May 11, 2018

BOARD OF COUNTY COMMISSIONERS
ORANGE COUNTY, FLORIDA

ADDENDUM NO. 4 / IFB NO. Y18-758-TA

SOUTH SERVICE AREA/EAST SERVICE AREA (SSA/ESA) 36-INCH POTABLE
WATER MAIN, 24-INCH RECLAIMED WATER MAIN AND J. LAWSON BLVD
POTABLE WATER RE-PUMP FACILITY

SSA-ESA
36 INCH WATER MAIN & 24 INCH RECLAIMED WATER MAIN & J. LAWSON RE-PUMP STATION
PUMP AND PIPING PLAN

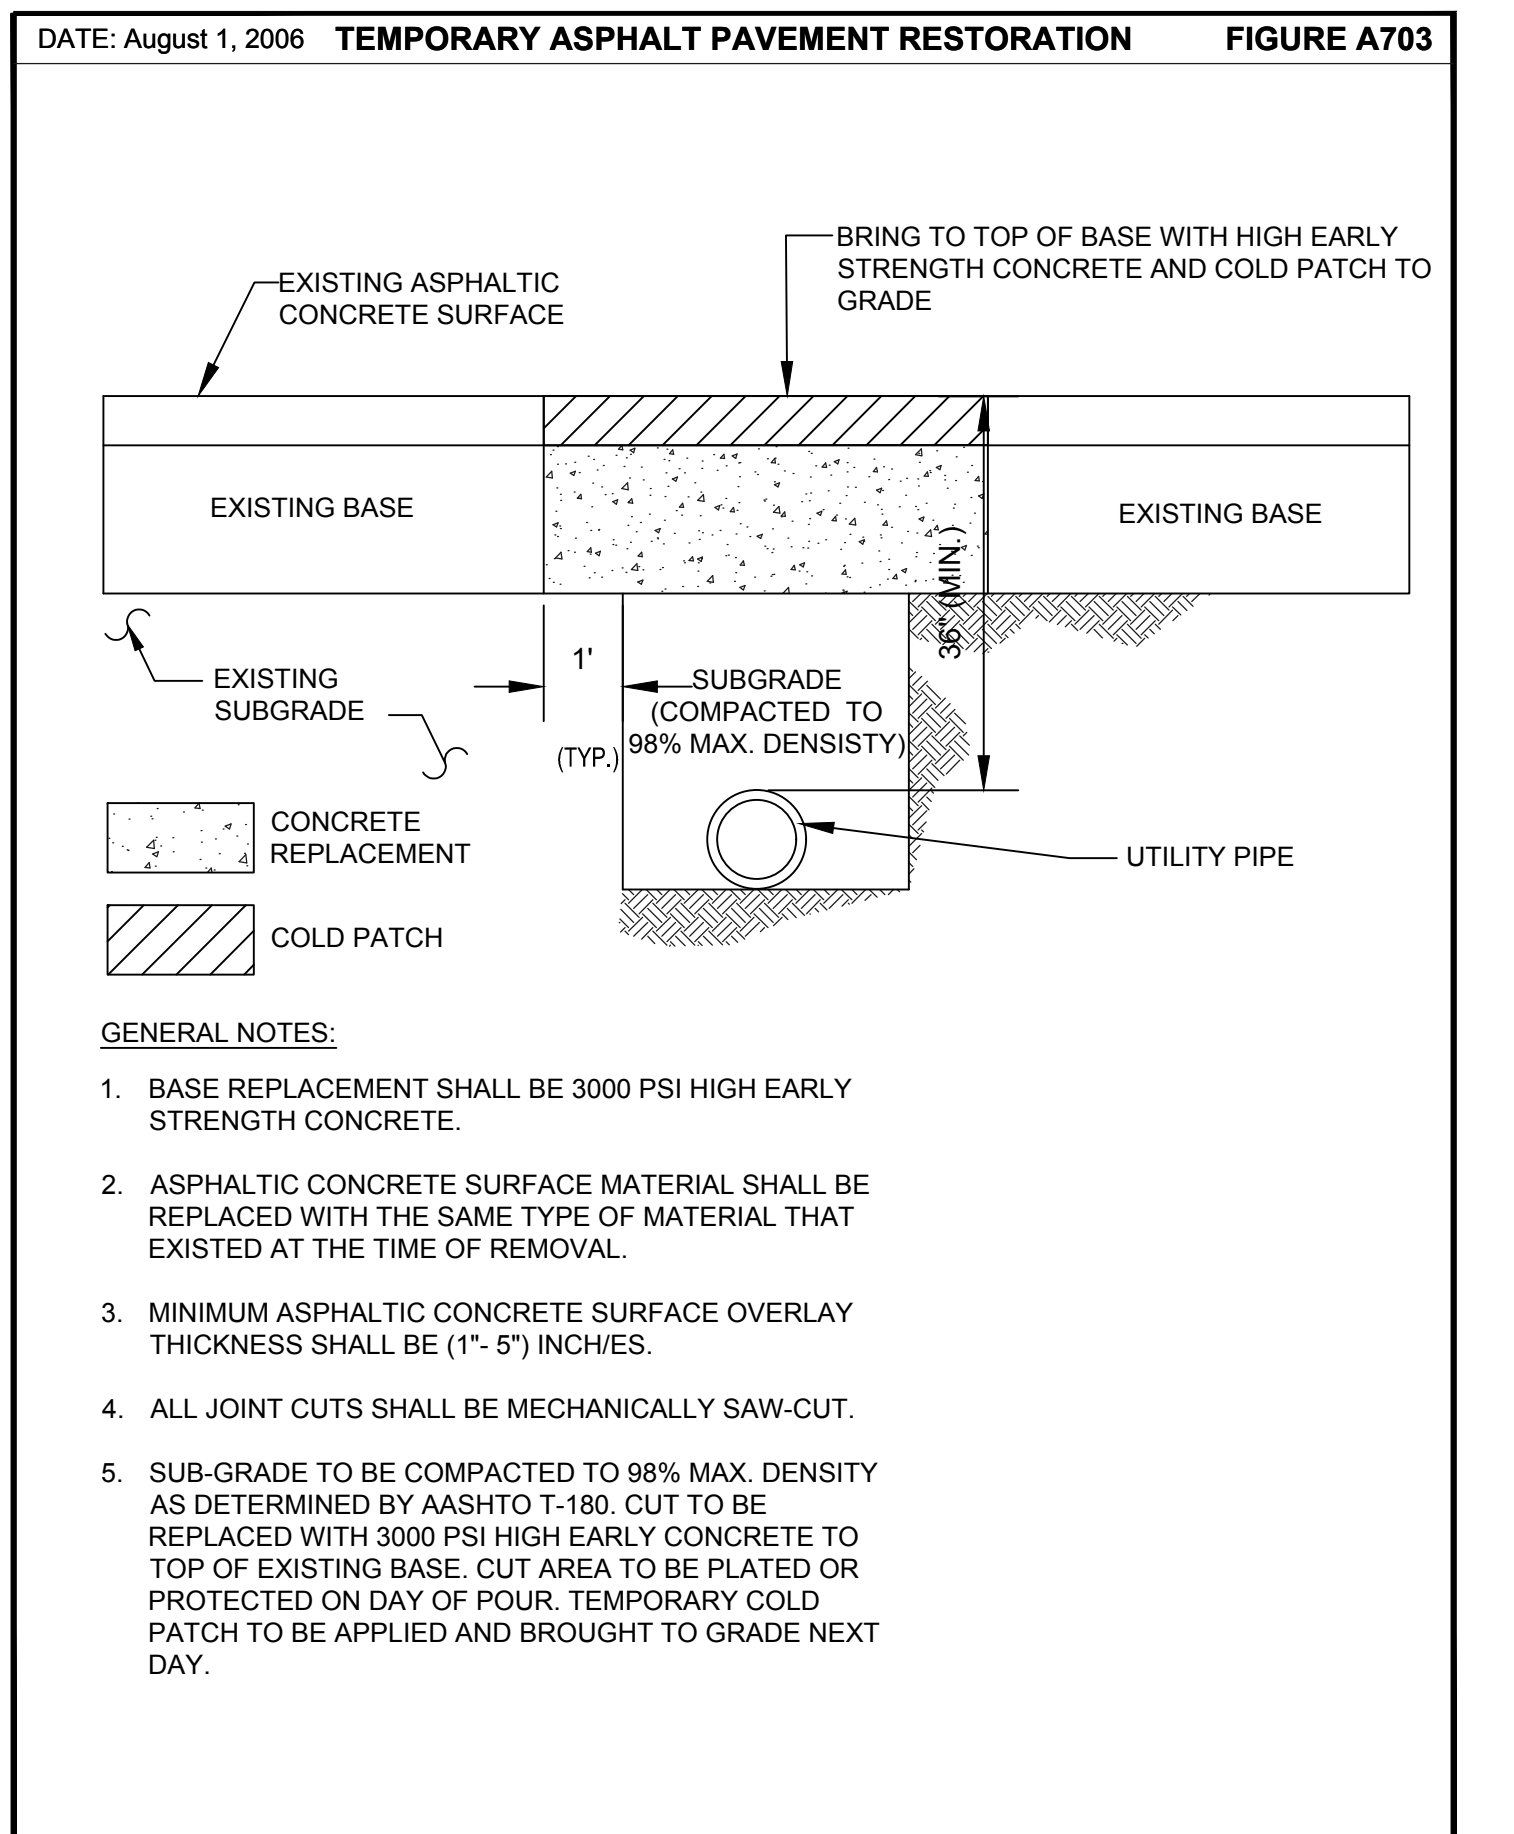
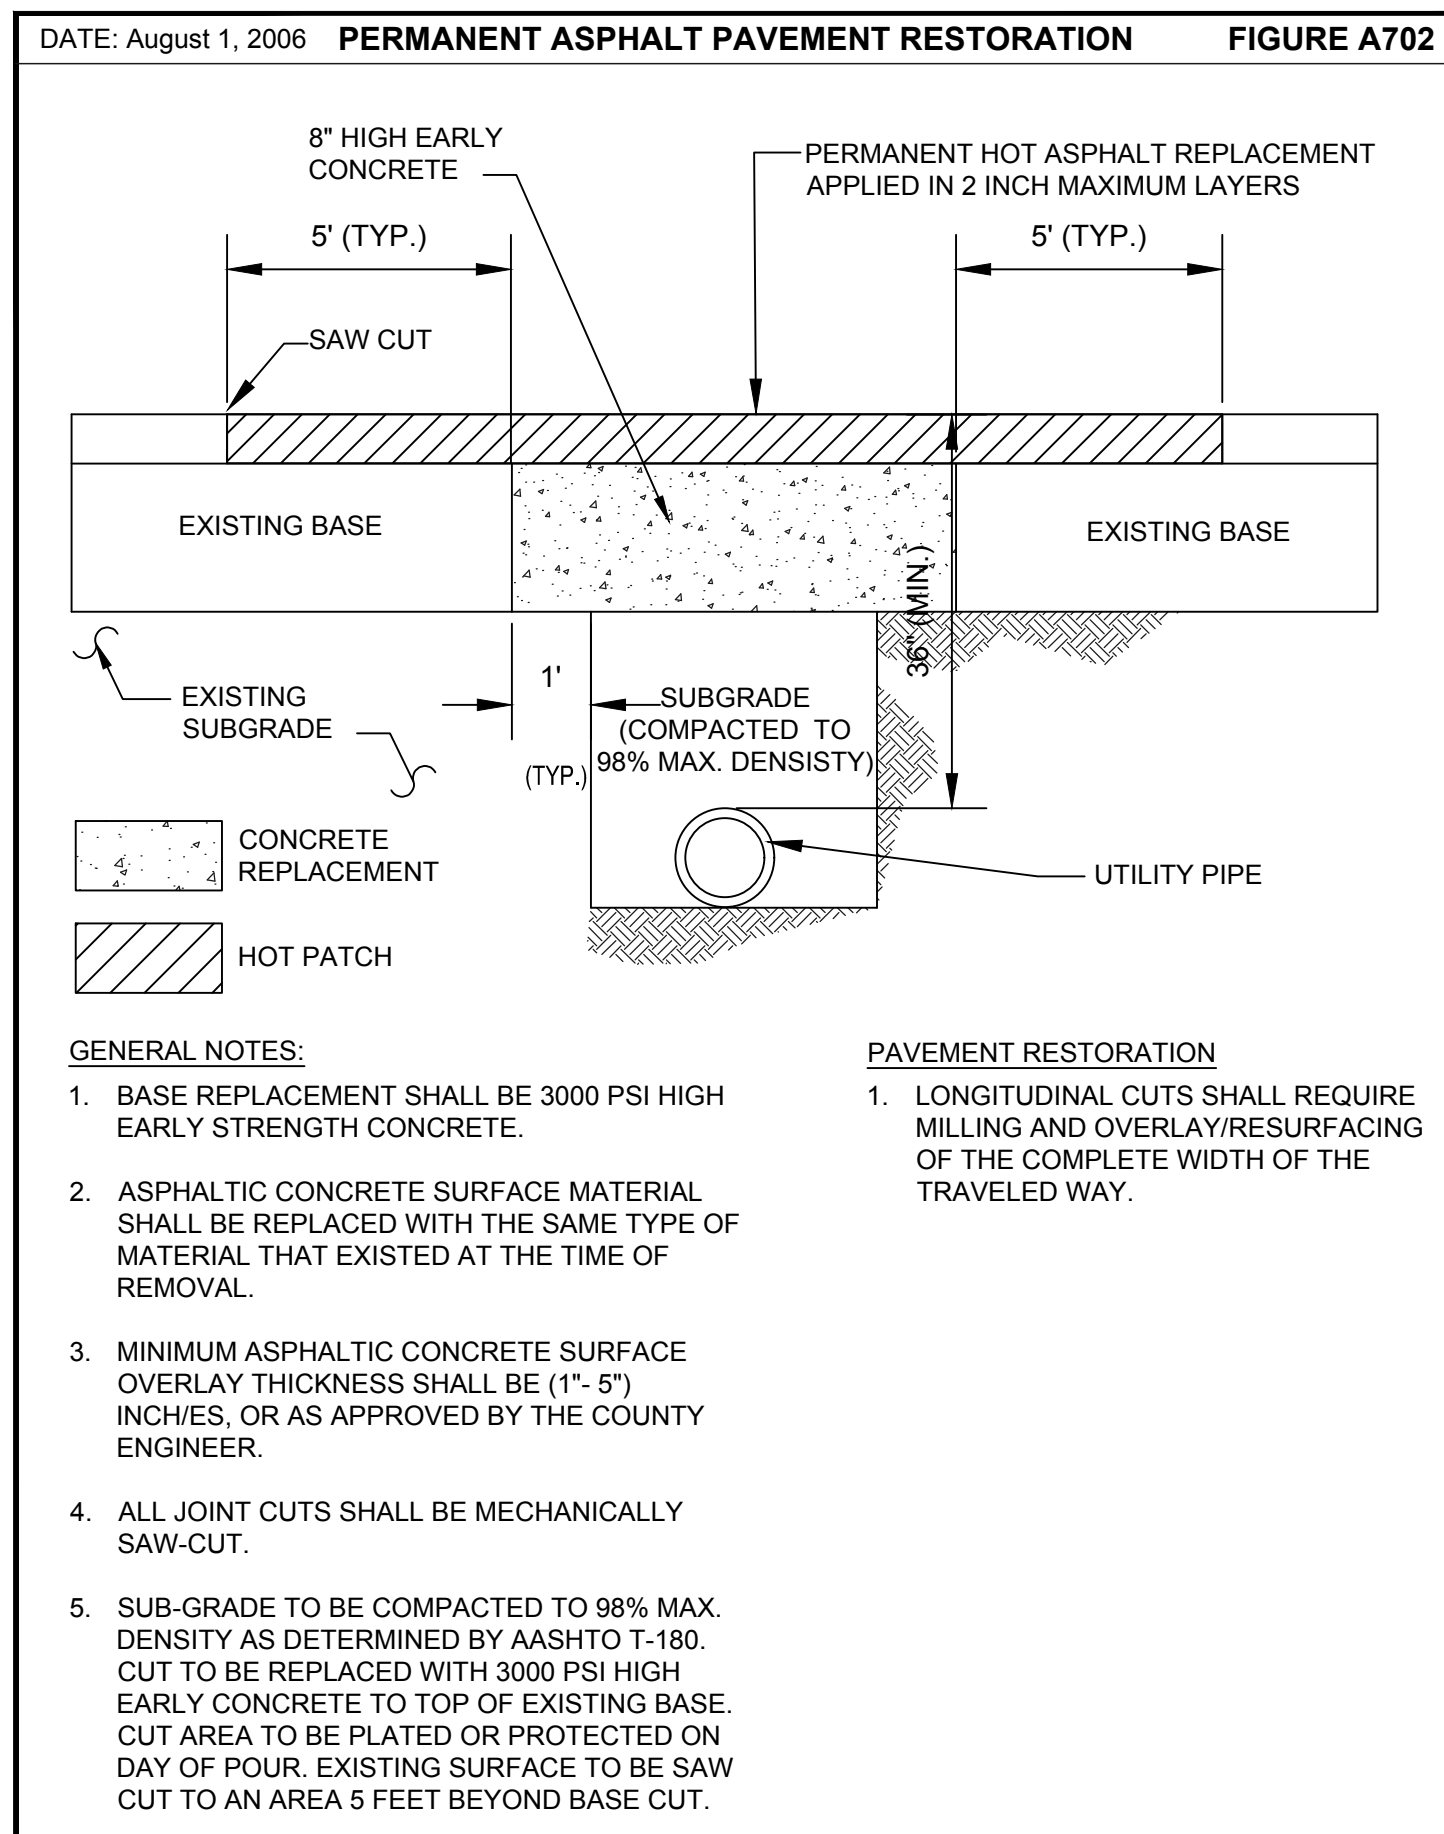
47. Q Regarding the Concrete Drive Detail on Sheet D-100, the 4th note mentions using tie bars to hold adjacent slabs in vertical alignment. Please clarify the tie bar spacing required.

DRAWING D-100 – CONCRET DRIVEWAY DETAIL

A: The Tie Bars or the keyed joints will not be required for this project.

Amend: Delete the fourth note regarding longitudinal construction joints
